March 4, 2002

**SUBJECT: Temporary Design Bulletin C02-03
Effective March 1, 2002**

FDOT NOISE WALL PILE/POST CONNECTION OPTIONS – GENERAL NOTES (Page 1 of 1)

**NOISE BARRIER WALL.
(REV 2-20-02)**

FDOT NOISE WALL PILE/POST CONNECTION - OPTION NO. 1B (Page 1 of 2)

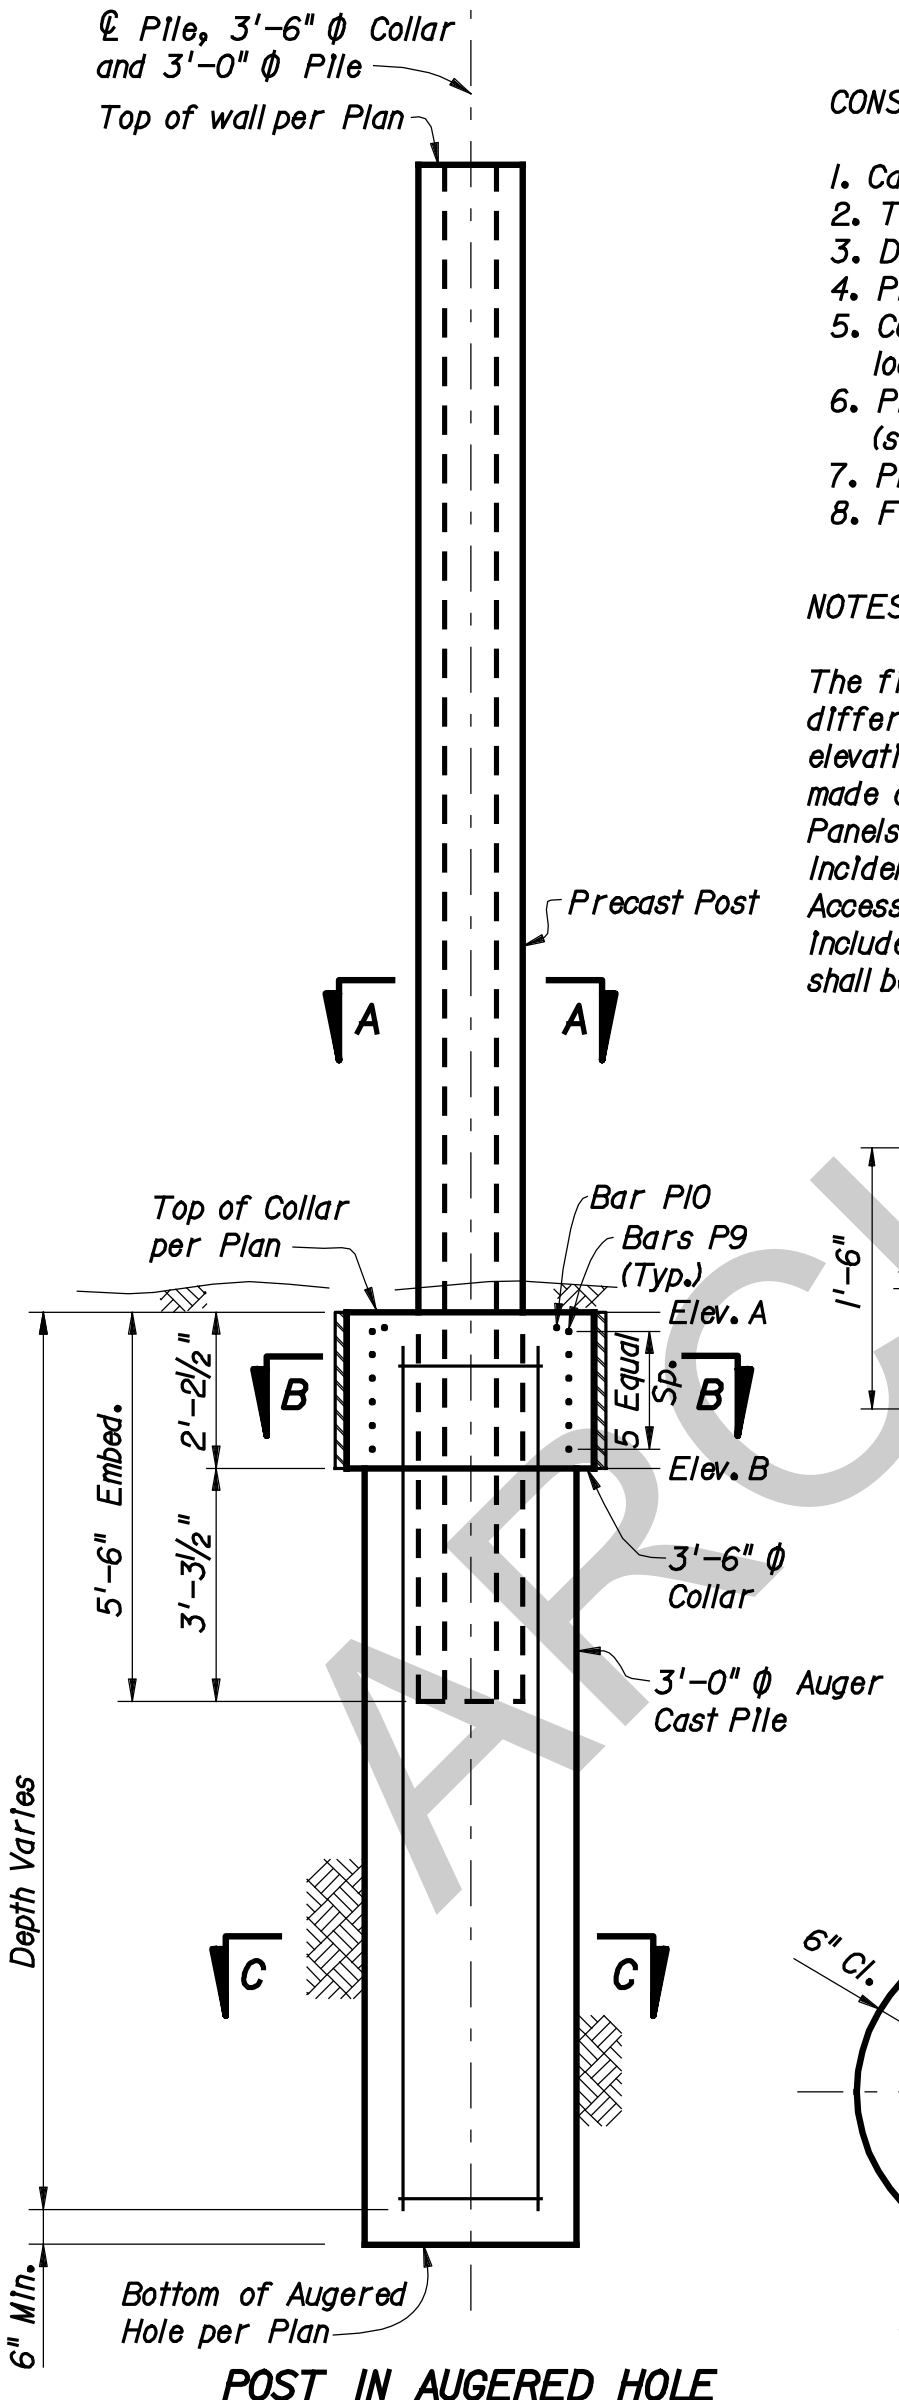
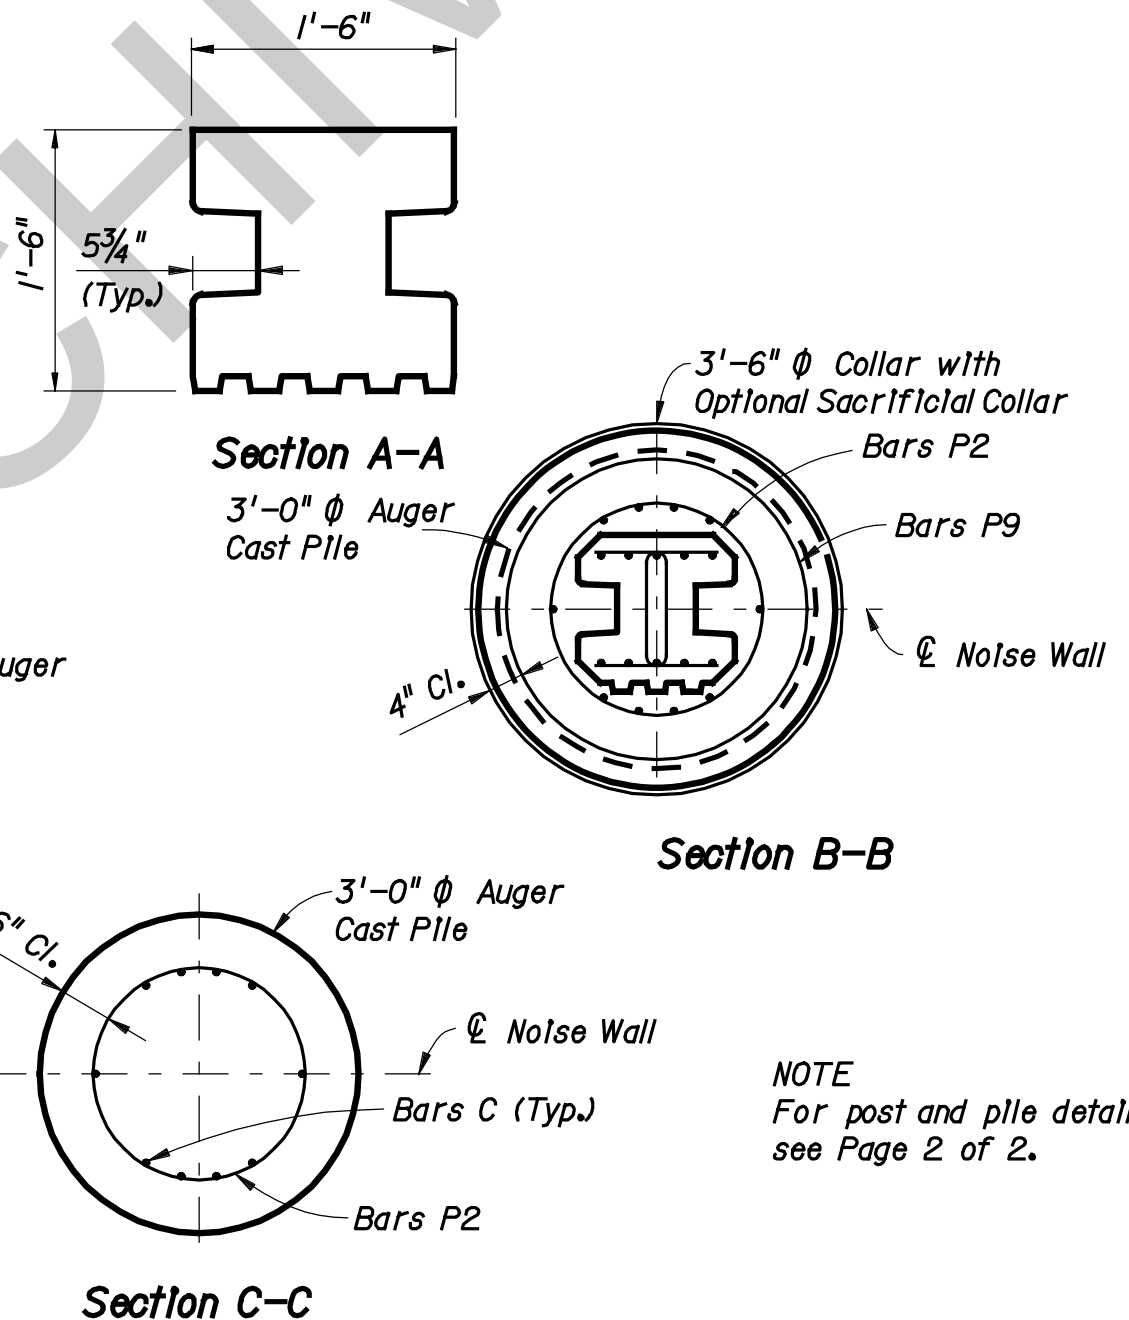
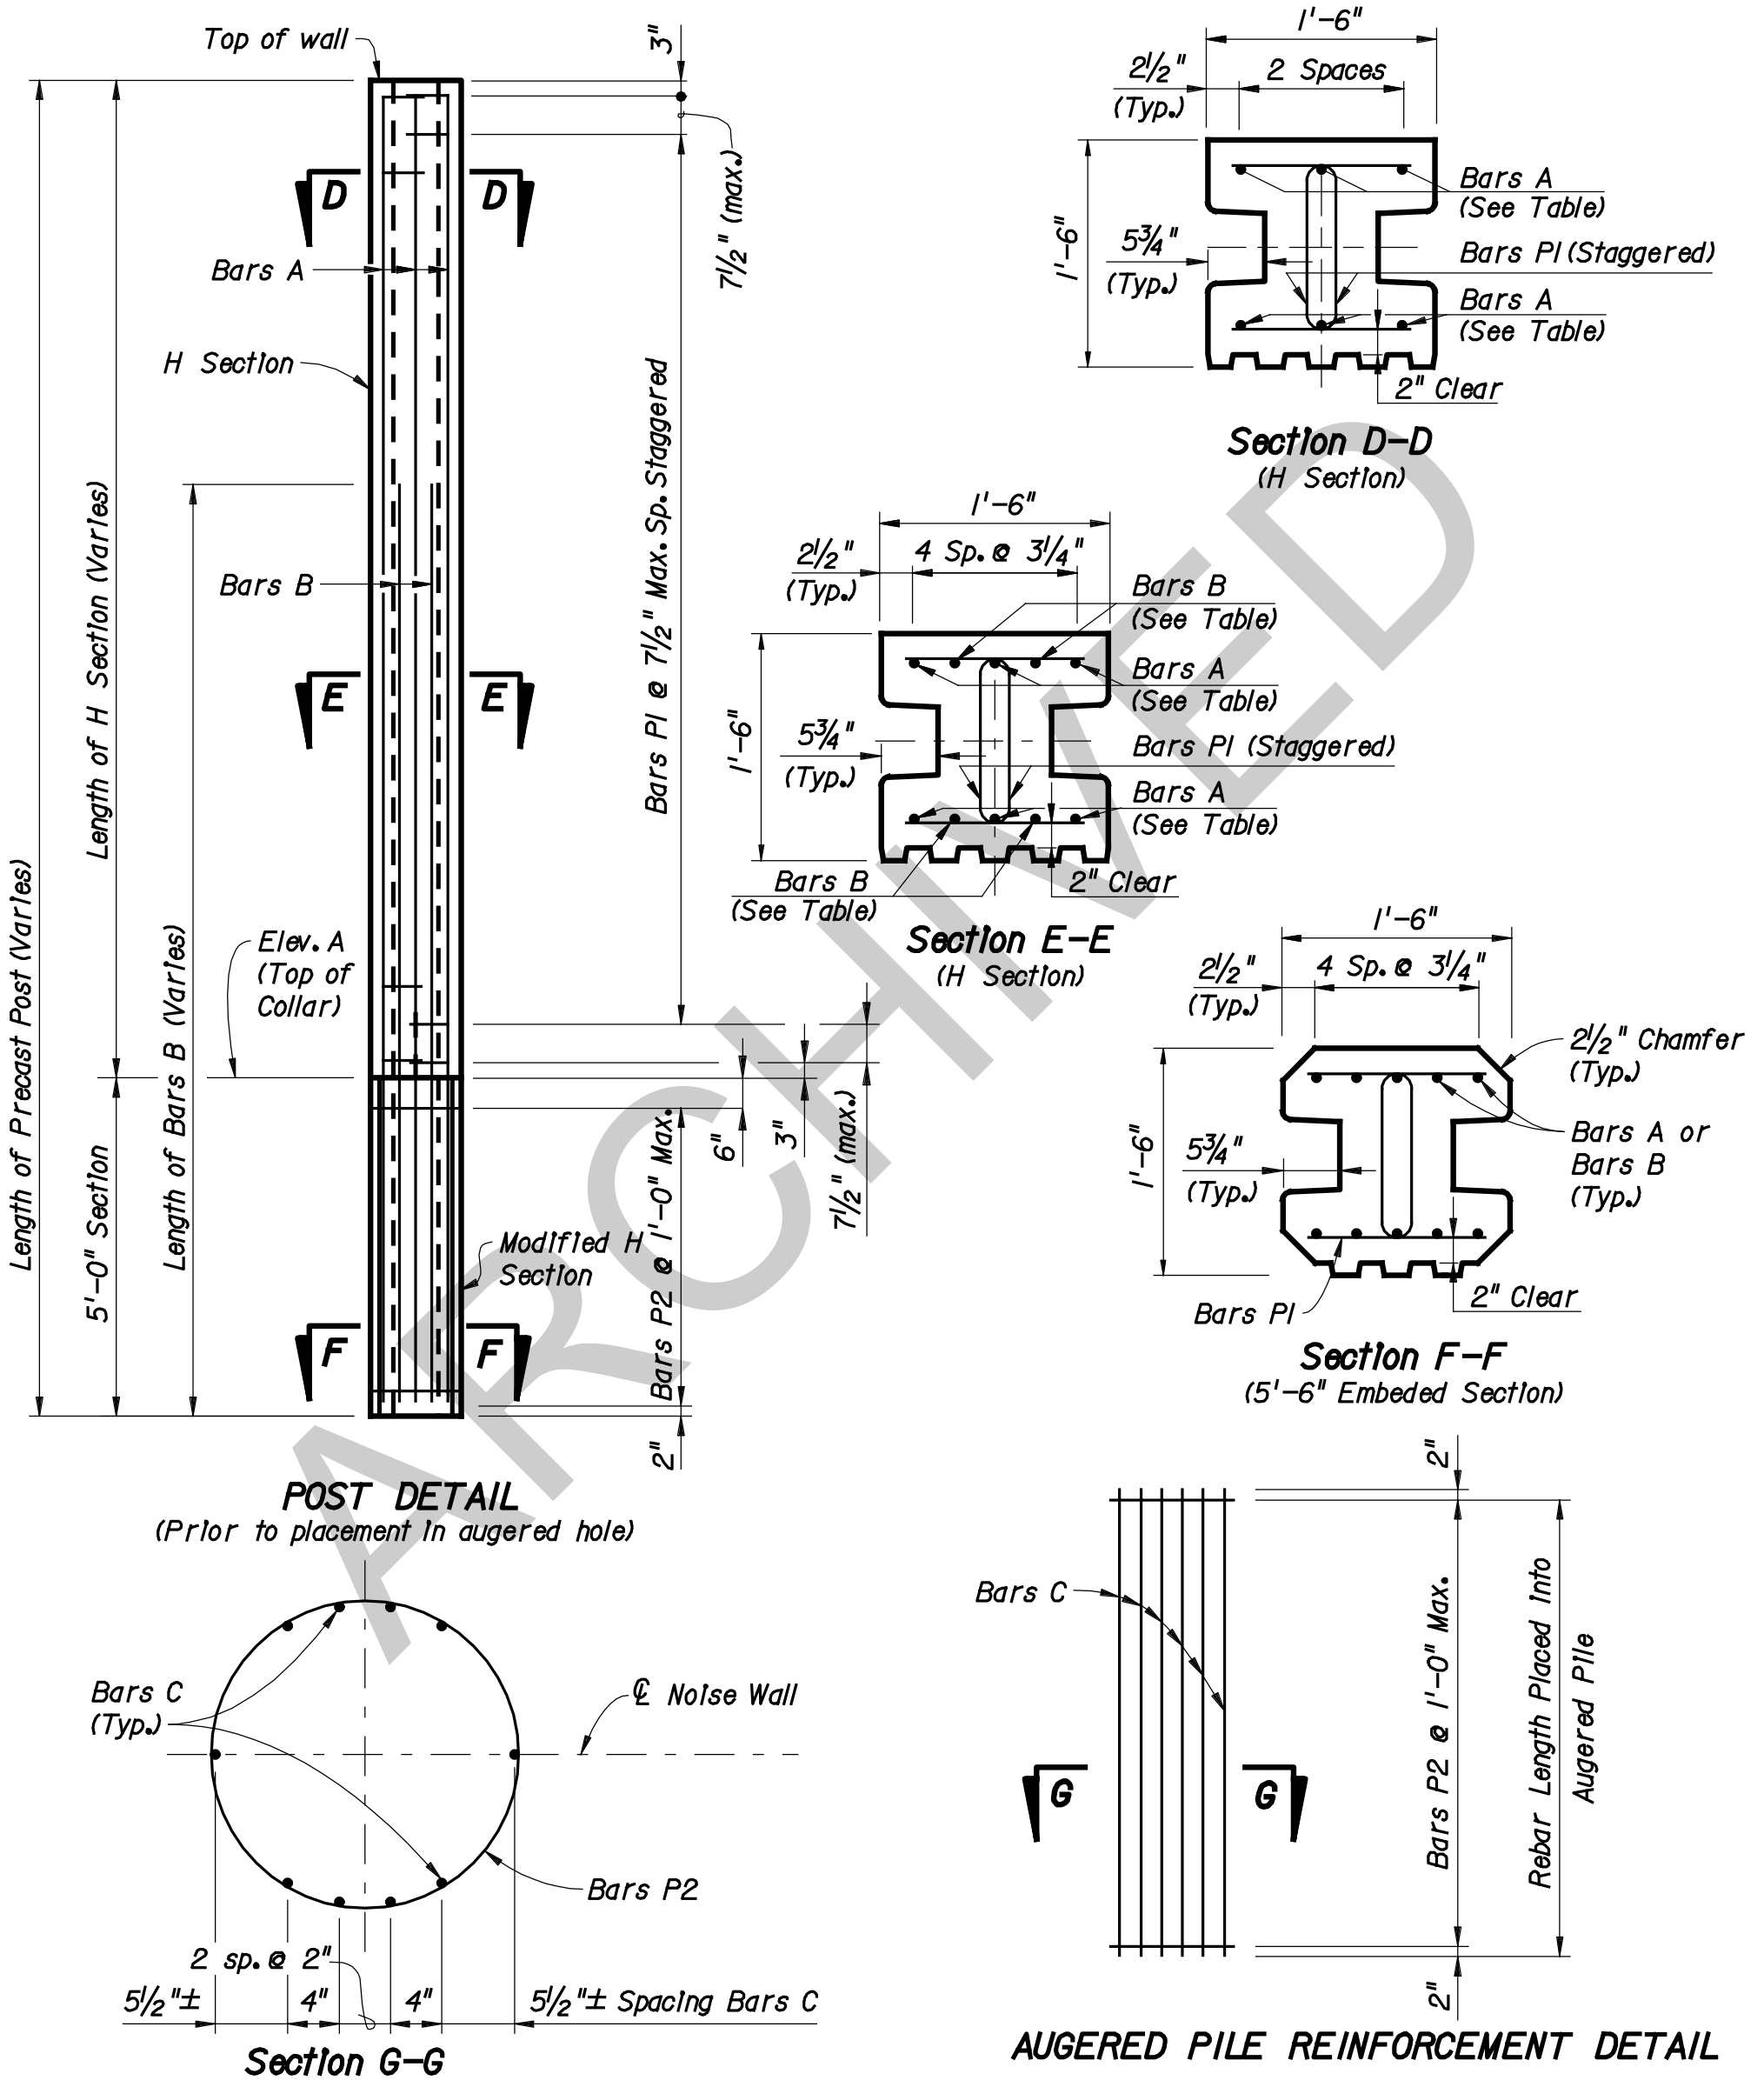
Requires casting the concrete post an additional five (5) feet below the bottom of the post, using the modified section shown in Section F-F on page 2 of 2 of Option No. 1B. Reinforcement Bars A and B in the post shall be cut off five (5) feet below the bottom of post and disposed of by the contractor. The additional reinforcement, shown in the Augured Pile Reinforcement Detail shall be as follows:

Bars C shall be number 8 bars and shall extend from 6 inches above bottom of augured hole to 4 inches below top of collar. Bars P2 shall be number 4 bars, 7'-7" long and bent to a 1'-0 $\frac{1}{2}$ " radius.

1. Cast the concrete H Post. See post detail on Page 2 of 2.
2. Temporarily excavate to Elev. B in the vicinity of the post.
3. Drill and cast a 3'-0" ϕ auger cast pile. Fill the augered hole to Elev. B
4. Place the pile reinforcement into the auger cast pile. See Page 2 of 2.
5. Construct a template to support and properly align the pile in the correct location in the 3'-0" ϕ hole.
6. Plunge the pile into the 3'-0" ϕ hole. The bottom of the H Post section (see section A-A) shall be 5'-6" below Elev. A (Top of Collar).
7. Place the sacrificial casing or collar form and collar reinforcement.
8. Finish the concrete to Elev. A (Top of Collar).
